COMMENTS ON CONCEPTUAL ENGINEERING AND CEQA FOR THE WATERFIX PROJECT

TOM WILLIAMS and DEIRDRE DES JARDINS

Figure 1 Hu Jin-Jun and Xie Li, Li, PGA variation with depth at soil site

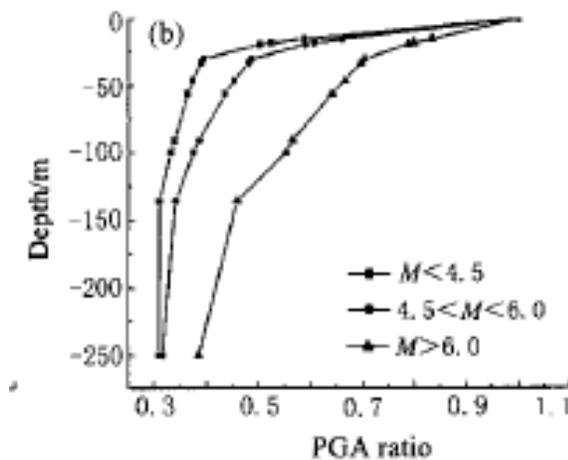
However, seismic data from the CSMIP Strong-Motion Geotechnical Array shows that the assumption of 50% attenuation may be wrong. Following the Santa Monica freeway collapse in the Northridge Earthquake, CalTrans has done long-term seismic monitoring

A 2005 study by Chinese engineers, Variation of earthquake ground motion with depth, Hu Jin-jun & Xie Li-li,¹⁶ analyzed the data from these sites. The 2005 study found that peak ground acceleration (PGA) in the deep alluvial soils falls off slowly for large magnitude earthquakes (Section 3.1.2, Soil site, p. 77.) The graph from section 3.1.2 is reproduced on the following page and indicates that a peak ground surface acceleration is reduced by 30% down to 70% of that at surface at a depth of 40-50 meters (120-160 feet) and is approximately correct for large magnitude events in deep alluvial deposits. An attenuation value of 50% is too large, compared to 30% of PGA.

Figure 2 Settlement trough

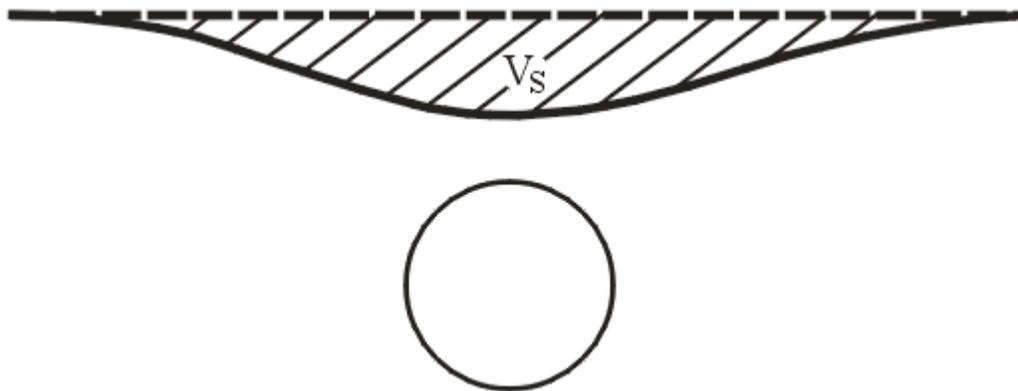
Tunneling boring machines excavate a larger amount of soil than is replaced by the volume of the tunnel lining, which typically causes a wide, shallow settlement trough on the surface. The over-excavation is measured by the volume of ground loss, which is defined as the percent difference between the volume of excavated soil and the volume of the tunnel lining. The volume of the settlement trough on the surface can be as large as the volume of ground loss. If groundwater is drained for tunnel construction, soil layers above the tunnel could settle even further.

Figure 3 Volume Losses Observed on the CTRL, ITA 2007.

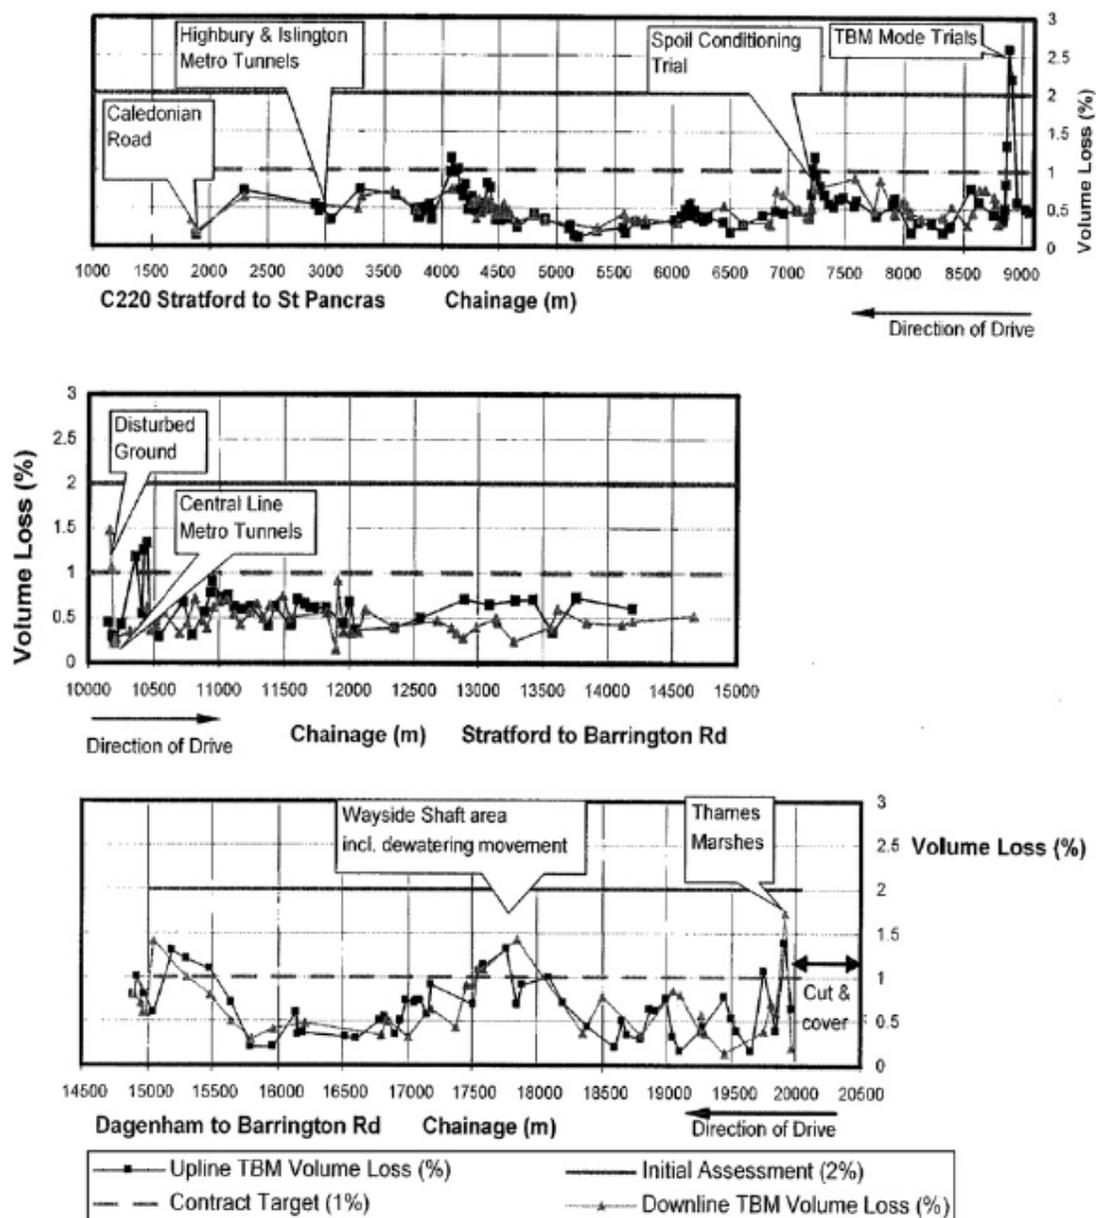
The Final EIR/EIS refers to Settlements induced by tunneling in Soft Ground, by the International Tunneling and Underground Space Association, 2007³³. The following graphs, from that document, show the ground volume loss in the tunneling for three London segments of the London Channel Tunnel Rail Link. The mean ground loss was around .5% for many segments, but the maximum was over 2.5% in the initial trials. In the Stratford to St Pancras link, once the tunnel ground volume loss exceeded 1, the boring was stopped and the tunnel boring machine was reconfigured for clay soils.

The LCRT construction was tightly monitored and had provisions to stop tunneling when ground loss exceeded 1%. The 1% ground volume loss would be an appropriate criteria for maximum allowed ground loss for tunnel boring. The Final EIR/EIS needs to clarify if that ground loss criteria is being specified, and also discuss whether it is appropriately
